SUBJECT: AUTHORIZATION OF THE TROJAN REACTOR VESSEL PACKAGE
FOR TRANSPORT

SAFETY EVALUATION REPORT

Trojan Reactor Vessel Package

FIGURE 1. Trojan Reactor Vessel Package (TRVP)

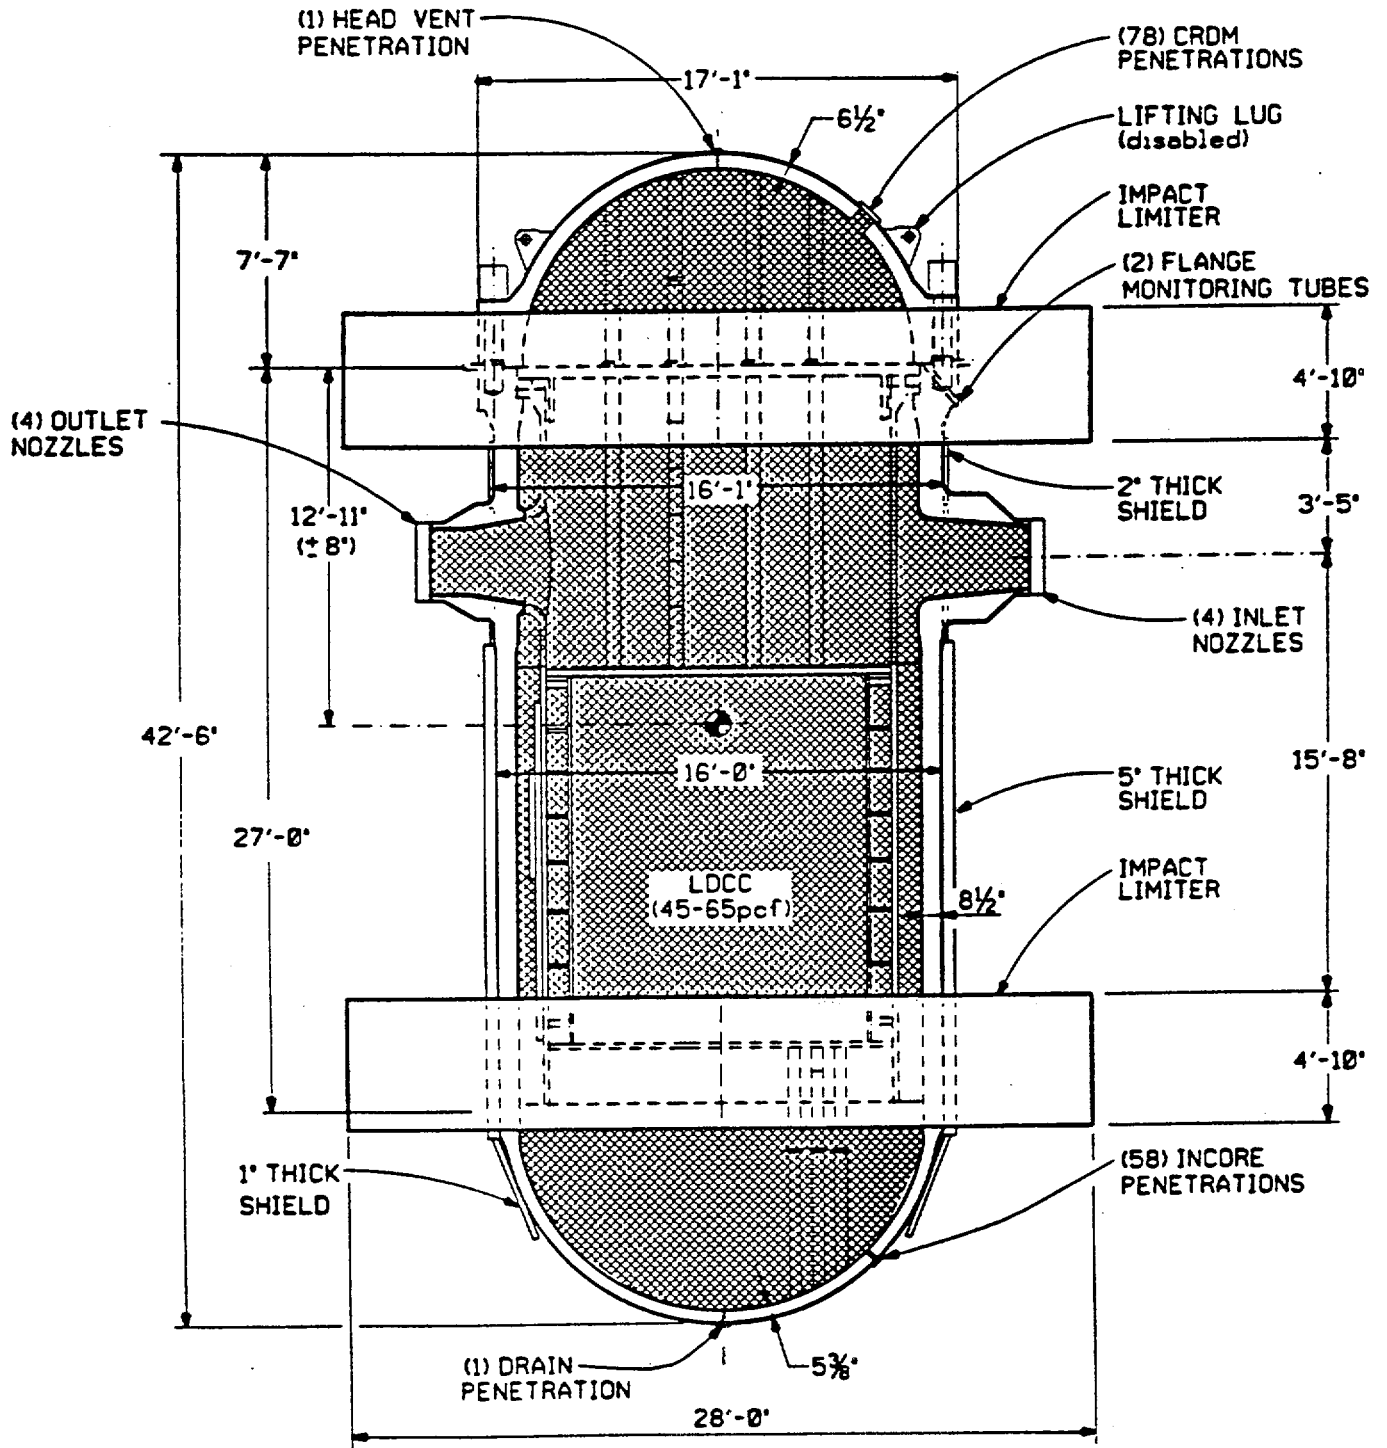
The TRVP consists of a reactor pressure vessel and its internal components, filled with concrete, with steel shielding installed on the exterior surface of the reactor vessel (Figure 1). The reactor vessel is a carbon steel cylindrical shell with an integral lower head and a removable upper head. The upper head is attached to the vessel by 54 tensioned head studs and sealed by dual metallic O-rings at the flange surface between the reactor vessel and the upper head. All reactor vessel penetrations are closed with welded plates. The overall length of the reactor vessel is 42 feet 6 inches and the diameter is 17 feet 1 inch (excluding the nozzles). The vessel thickness (excluding the stainless steel shielding) varies from 5³/₈ inches at the lower head, to 6¹/₂ inches at the upper head, to 8¹/₂ inches at the core ring, to 10¹/₂ inches at the nozzle ring.
